**MAINE TURNPIKE AUTHORITY**

**ADDENDUM NO. 3**

**CONTRACT**  
**2021.02**

**WATER LINE AND UTILITY**  
**VAULTS**

PLAN VIEW - UTILITY VAULT

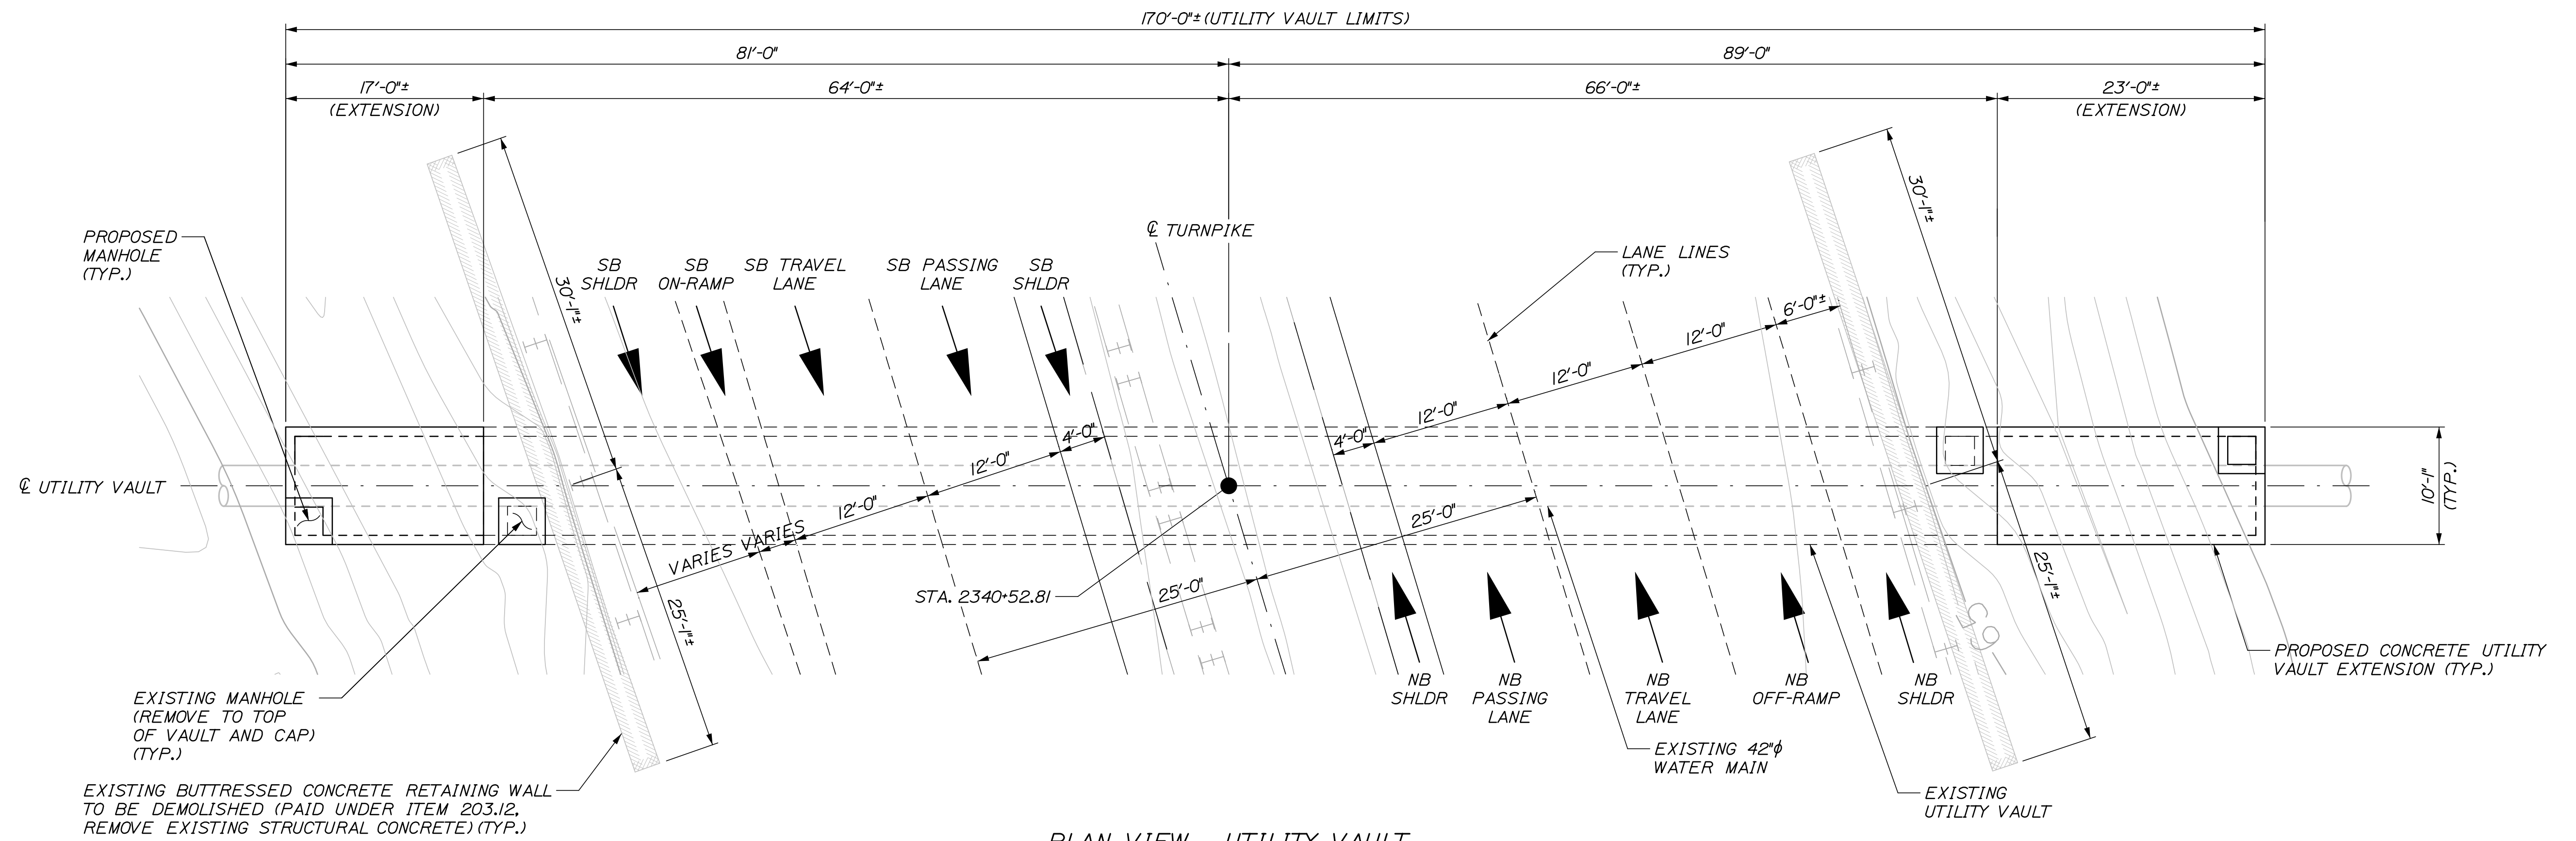
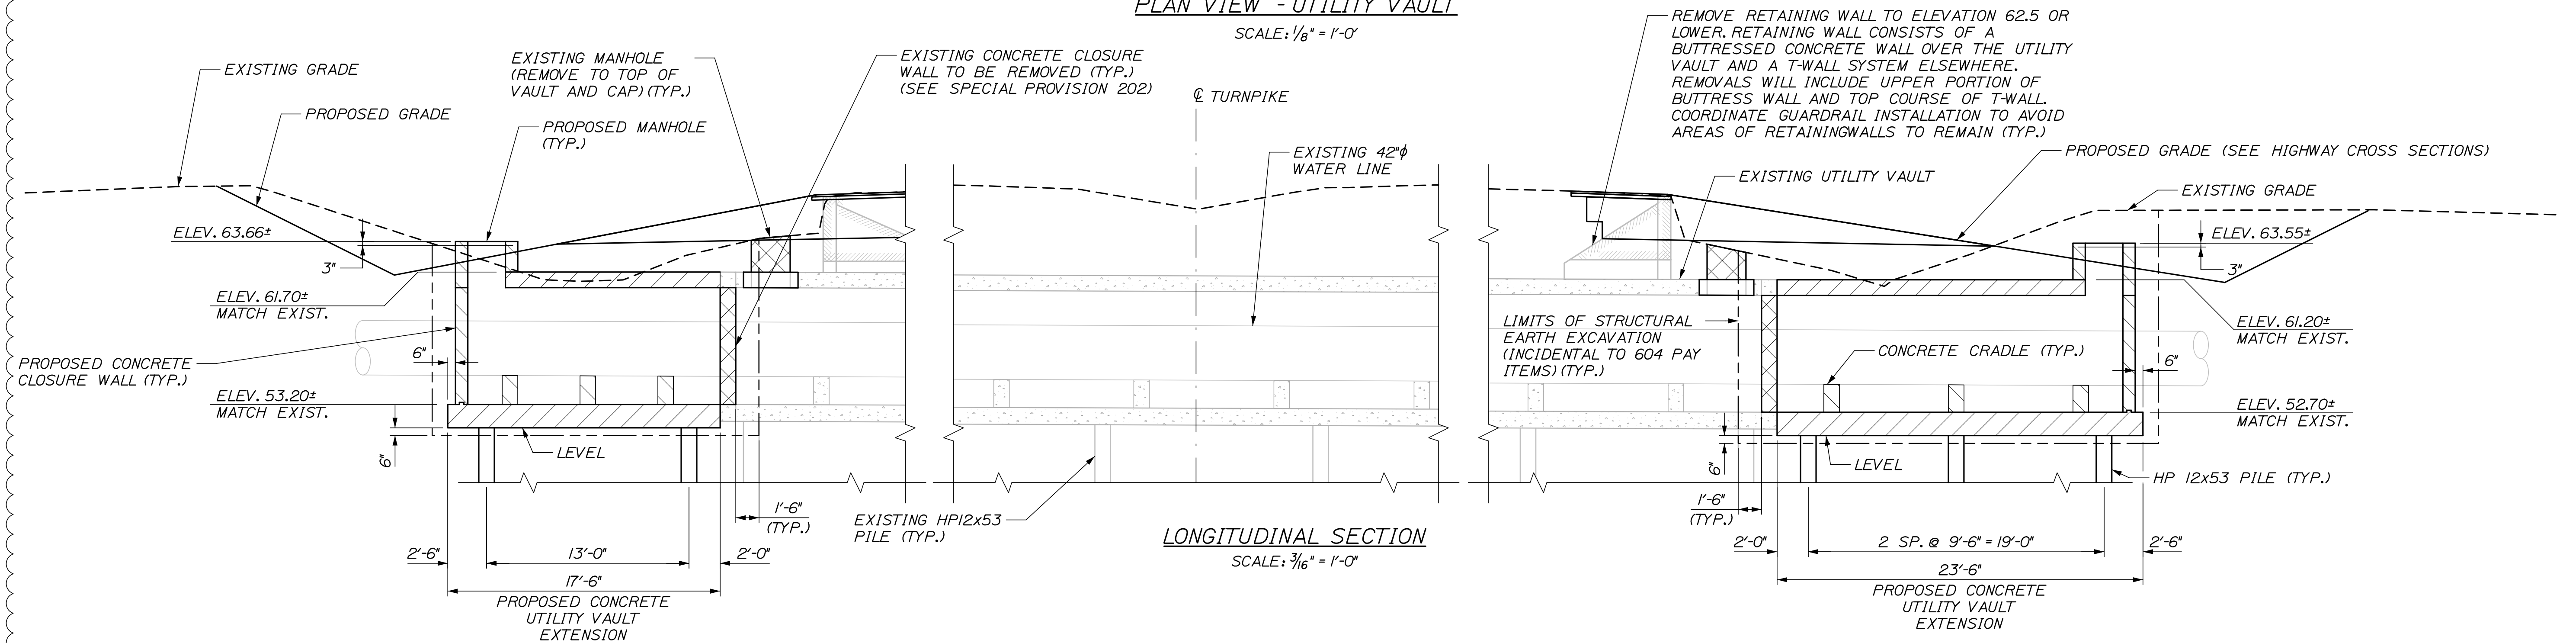
Scale:				Designed by:			
AS NOTED							
No.	Revision	By	Date				
1	ADDED RETAINING WALL DEMOLITION	BRG	06/21

UTILITY VAULT DETAILS  
 STA. 2360+02.55 - DETAILS II

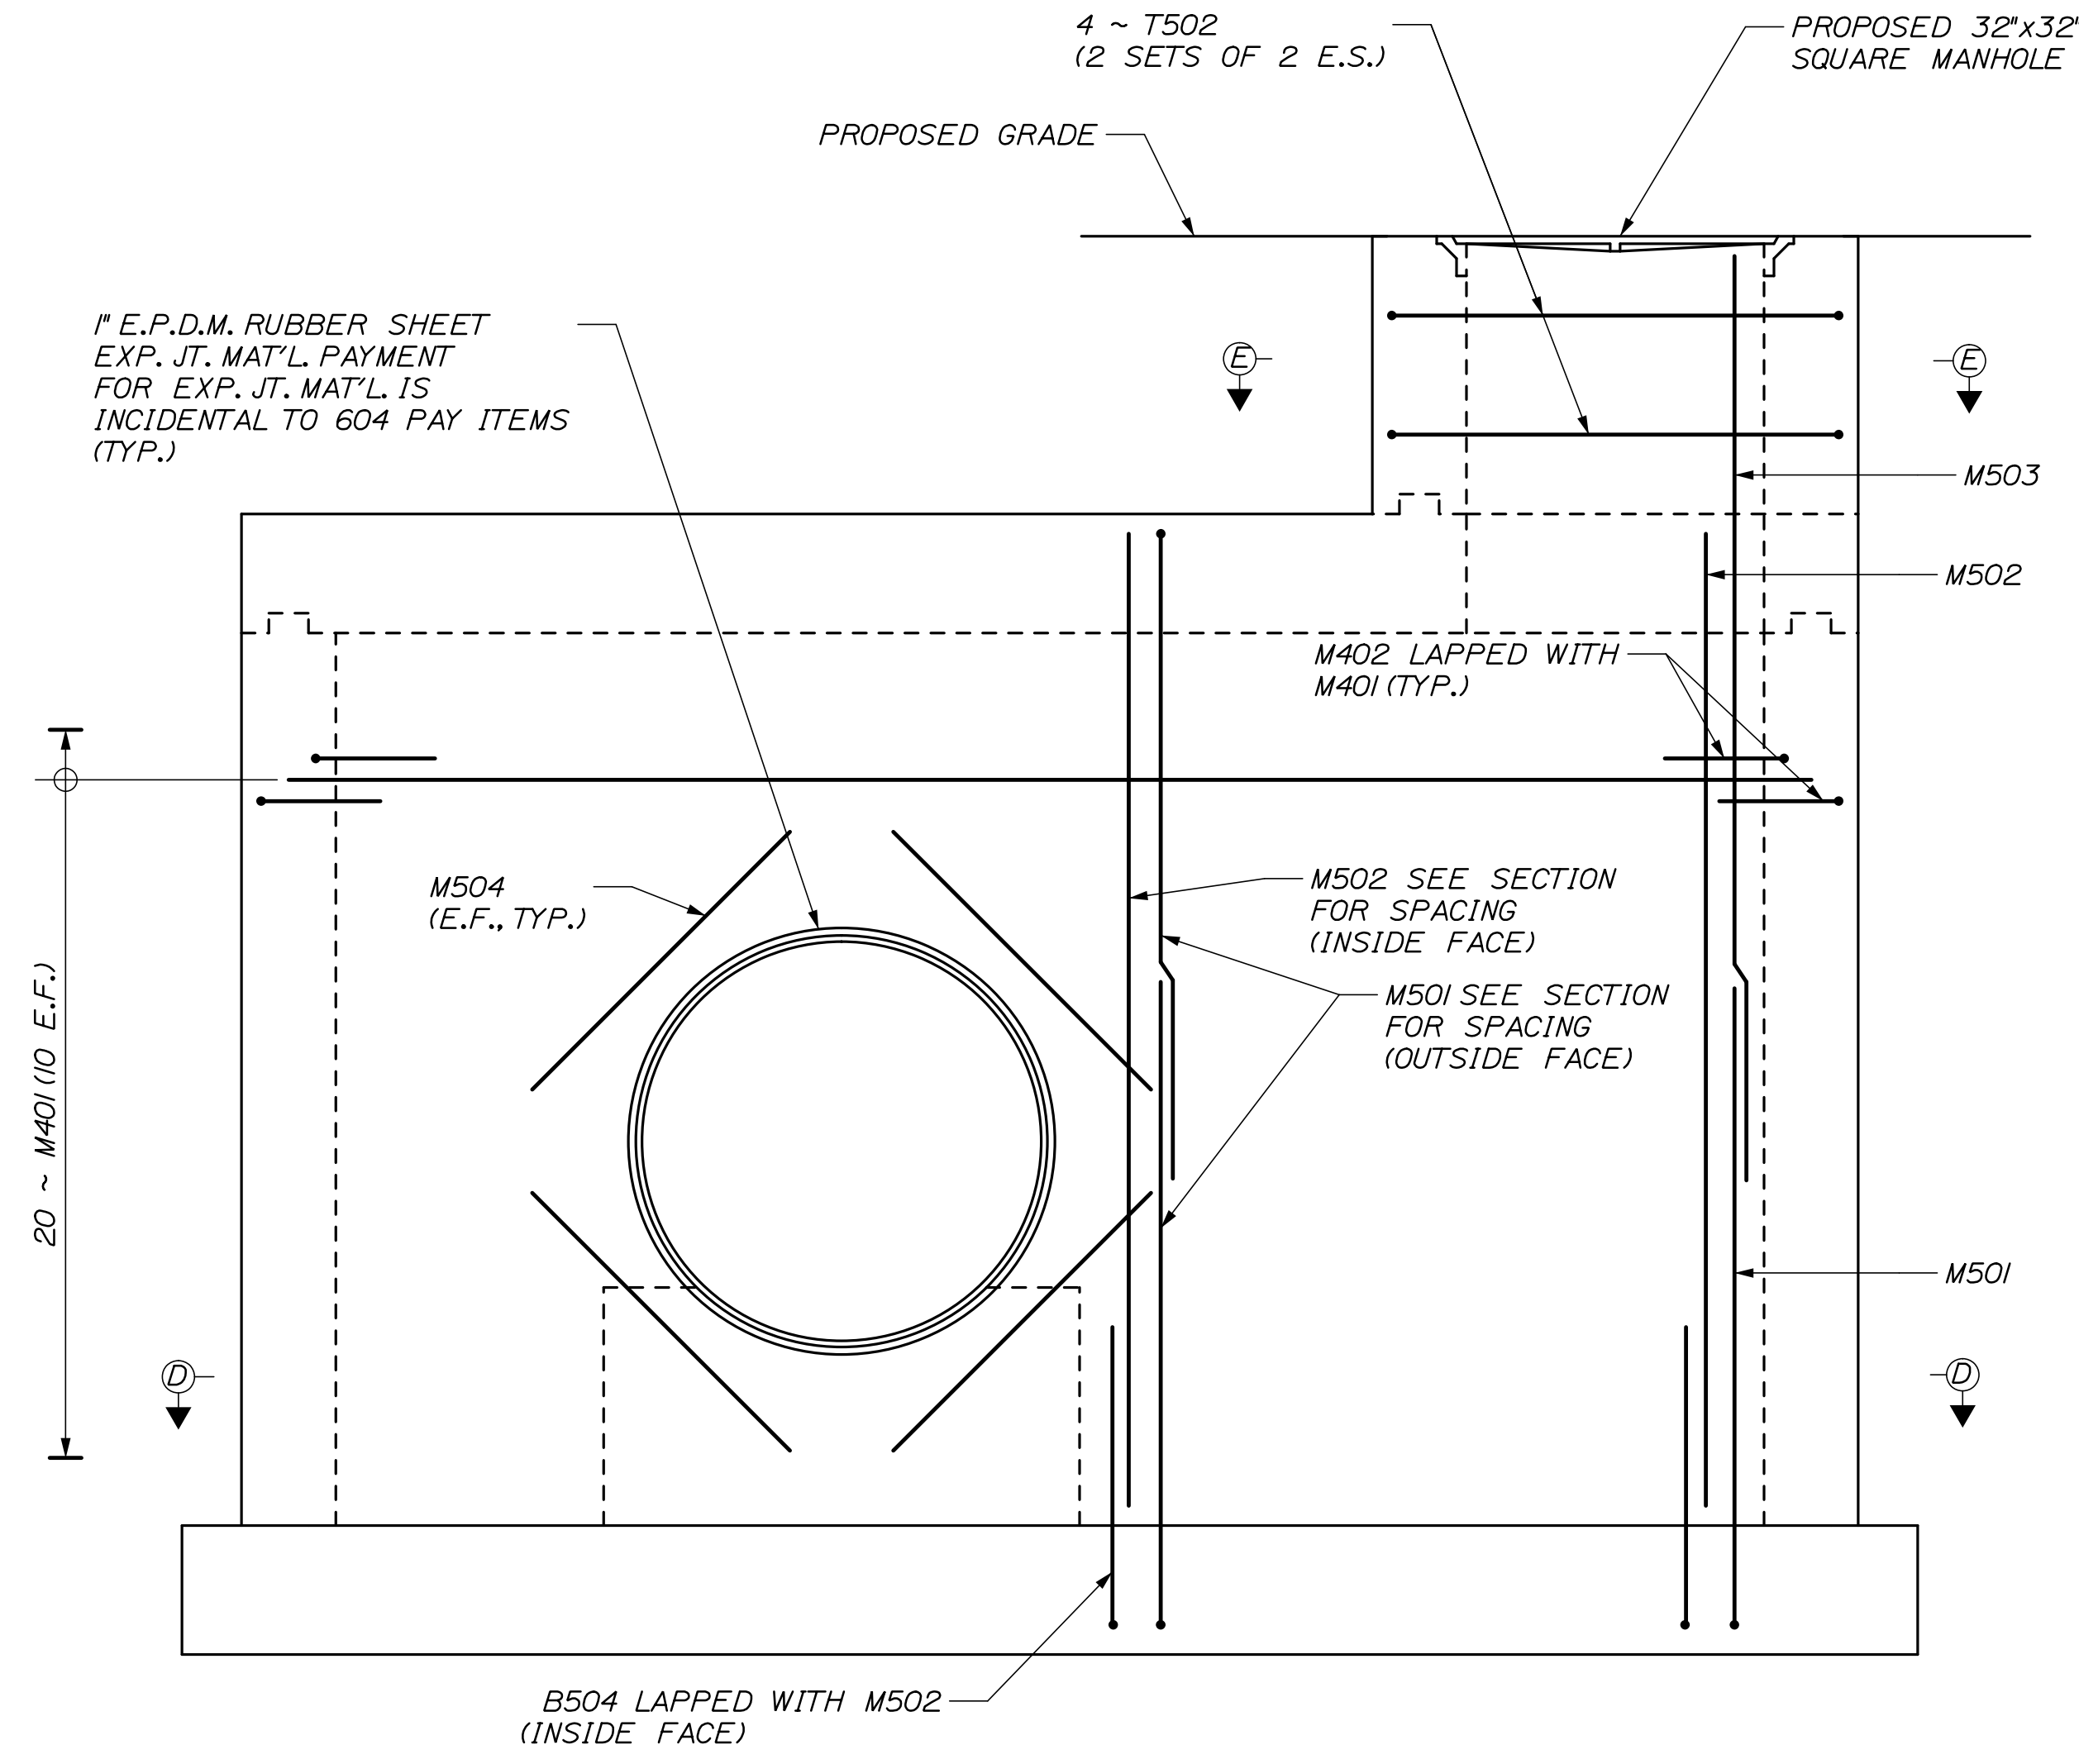
Question 2: Sheet 23 note 2 states “stainless steel strap shall be ASTM A666, type 201 and be installed at 2’-0” O.C. along the watermain pipe.” What are the limits of this work, is it just the new extensions or is it also the existing vault? The typical section shows the straps bolting to the cradles although the cradles are not every 2’.

Answer: Stainless steel straps are required for the new extension only. Stainless steel straps are required at all cradles in lieu of 24” O.C.

- FOR SECTIONS D-D AND E-E, SEE SHEET S-12.
- STAINLESS STEEL STRAP SHALL BE ASTM A666, TYPE 201 AND BE INSTALLED AT EACH CRADLE ALONG THE WATERMAIN PIPE.
- EXPANSION BOLT SHALL BE 3/4" STAINLESS STEEL HILTI QUICK BOLT WITH 6" EMBEDMENT OR APPROVED EQUAL.
